CORRECTIONS TO HOUSE PLAN FOR PEARLMAN'S

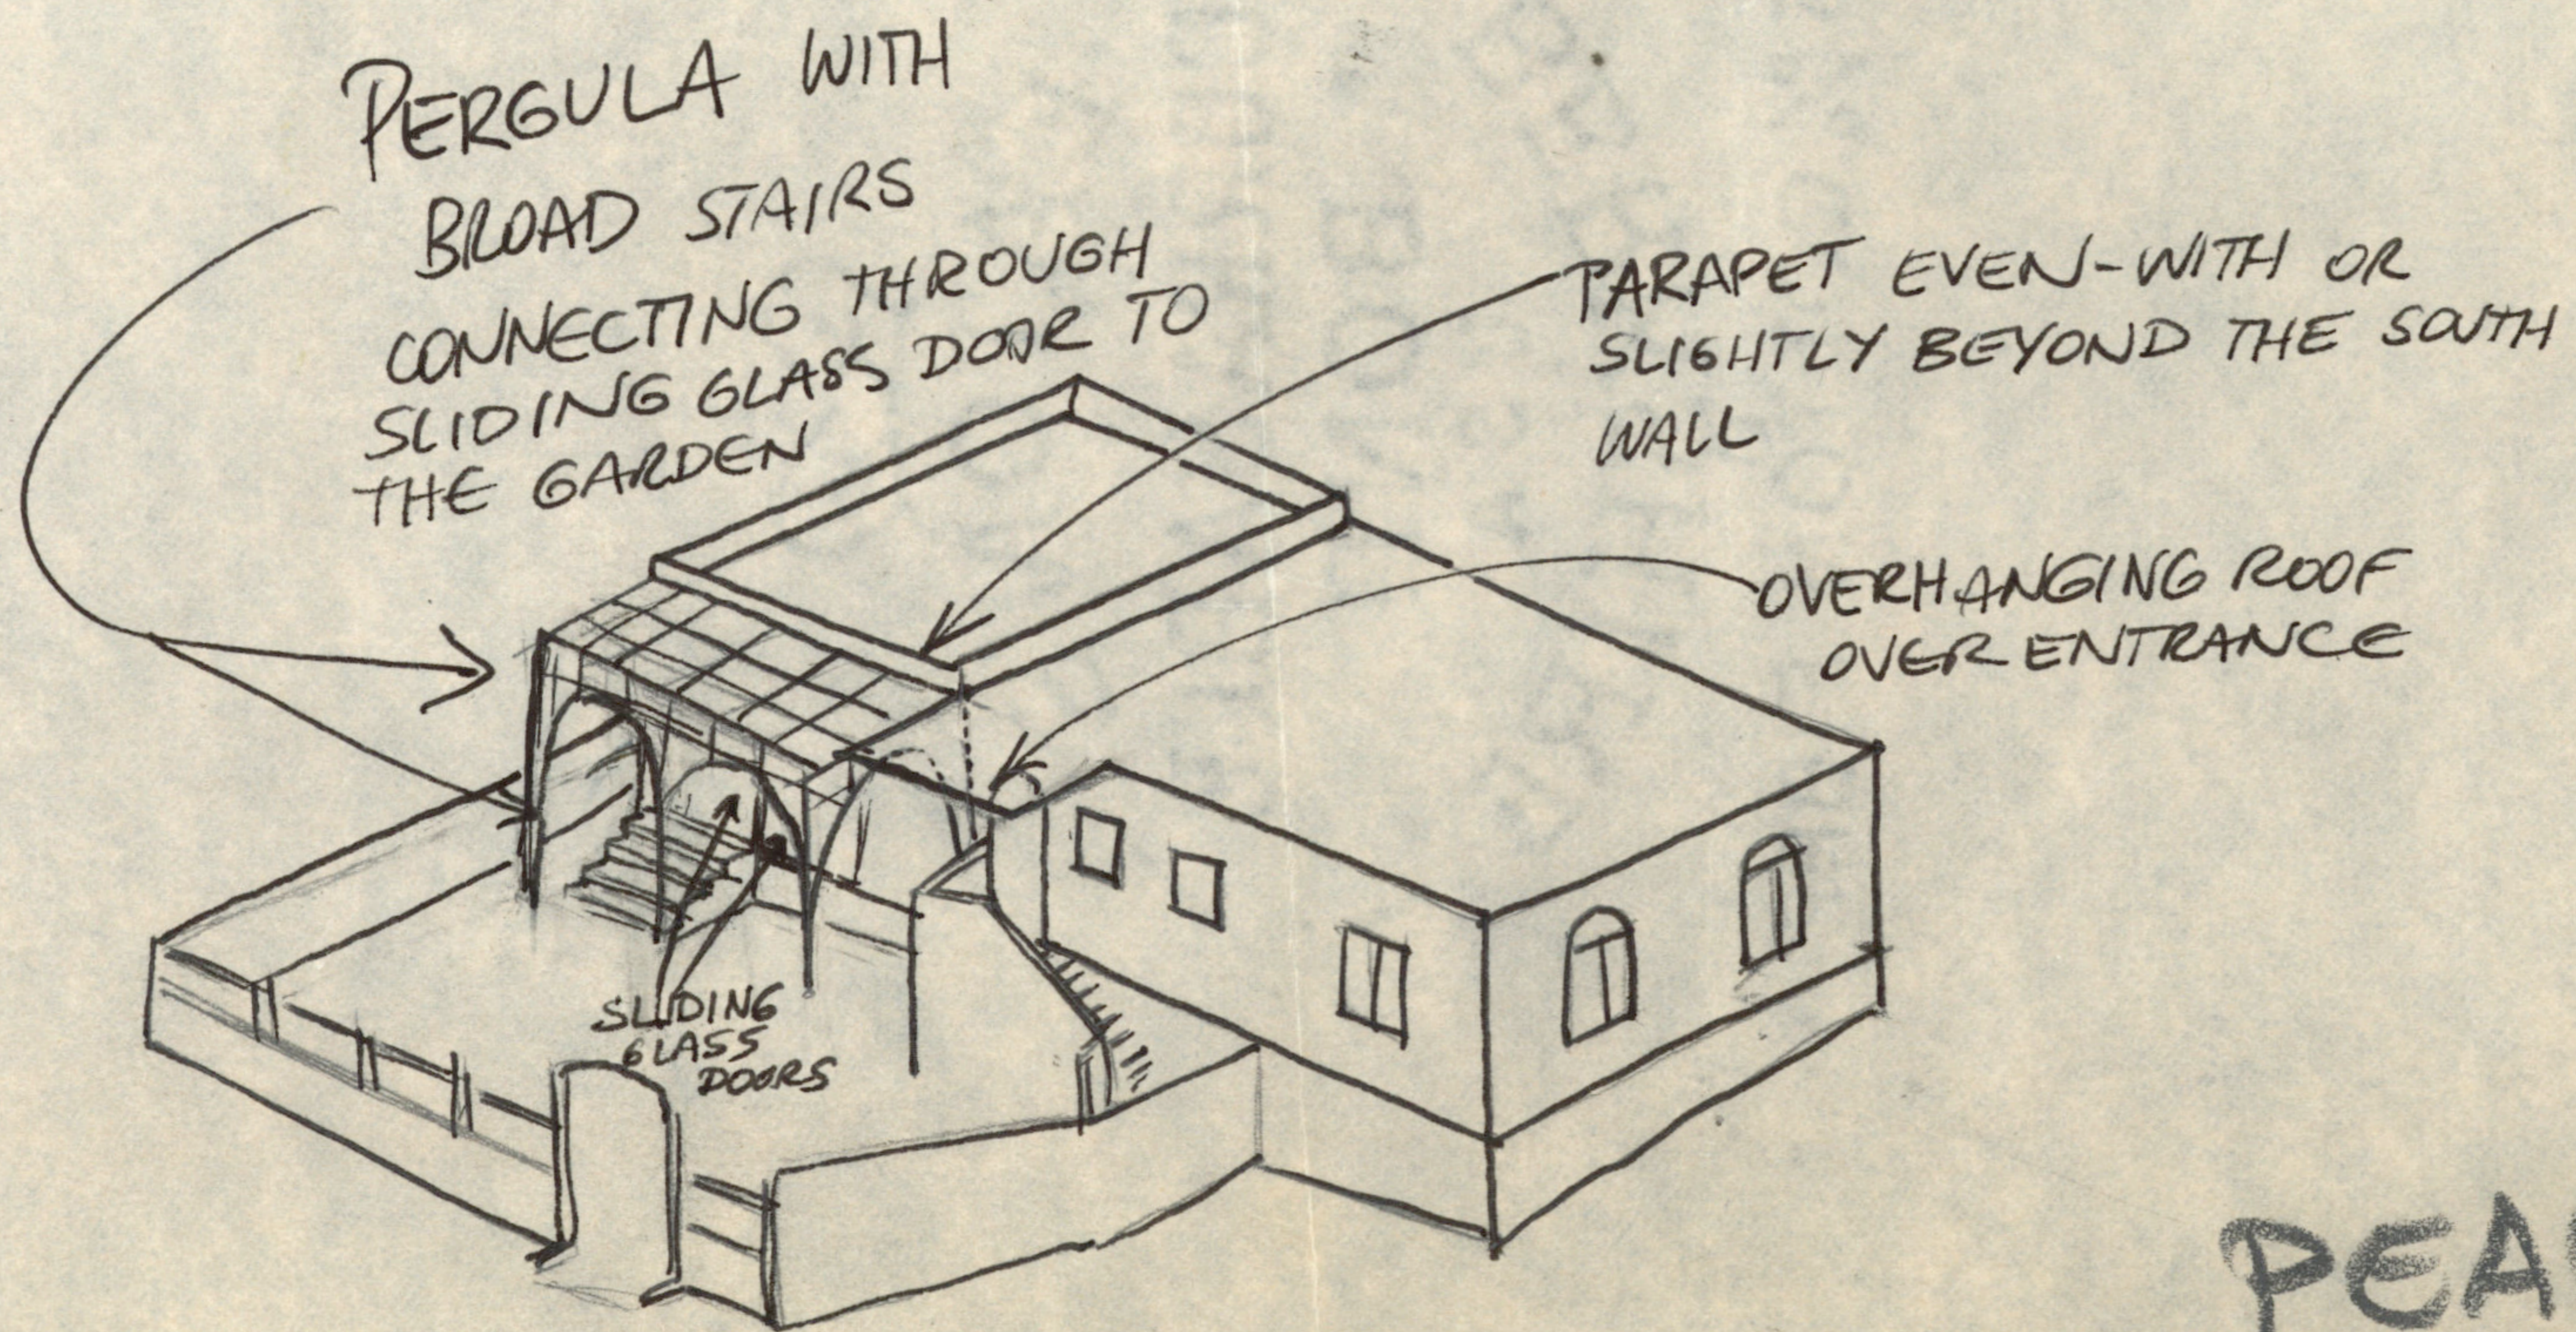
- 1) CHANGE THE SOUTH SIDE OF THE HOUSE OUTSIDE THE LIVING ROOM AS INDICATED IN THE ACCOMPANYING SKETCH (EXCHANGE BALCONY FOR PERGOLA, SHORTEN ROOF/PARAPET TO THE WALL'S EDGE; ADD WIDE STAIRS LEADING FROM LIVING ROOM THRU SLIDING DOOR TO GARDEN)
- 2) ADD SLIDING GLASS DOOR TO SOUTH SIDE OF LIVING ROOM, INSTEAD OF DOUBLE DOORS.
- ✓ 3) ELIMINATE ~~WEST~~ WINDOW ON WEST WALL OF LIVING ROOM, MOVE IT TO NORTH WALL (NICE VIEW NORTHWARD).
(LARGE VIEWING WINDOW)
- ✓ 4) ADD DOOR FROM KITCHEN TO NORTH SIDE (OUTSIDE) FOR ACCESS TO GARDEN, LAUNDRY-HANGING, etc. (SUGGEST N.E.-CORNER OF KITCHEN).
- 5) RAISE THE FLOOR LEVEL OF THE ENTRANCE ROOM AND THE W.C. TO THE SAME AS THE KITCHEN (ELIMINATE ITS STAIRS), ADD STAIRS FROM ENTRANCE ROOM TO LIVING ROOM.
- 6) ADD A SMALL SINK IN N.E. CORNER OF W.C.; ALSO, MAKE W.C. NARROWER TO ALLOW FOR

- 7) ~~DO~~ ALLOW ROOM FOR A SECOND TOILET, IN THE BATHROOM
(THIS IS STANDARD PRACTICE BY HOUSING MINISTRY HERE).
- 8) ADD AN OVERHANGING ROOF OVER THE ENTRANCE (SEE SKETCH)
- ✓ 9) ADD STAIRS TO THE SECOND FLOOR VIA OUTSIDE STAIRCASE
(WEST SIDE WOULD SEEM THE BEST - THIS WOULD REQUIRE WIDENING THE SPACE BETWEEN THE WESTERN SIDE ^{SEEM TO} OF THE LIVING ROOM AND THE PRESENT WESTERN GARDEN WALL, WHICH COULD PERHAPS BE MOVED FURTHER WESTWARD).
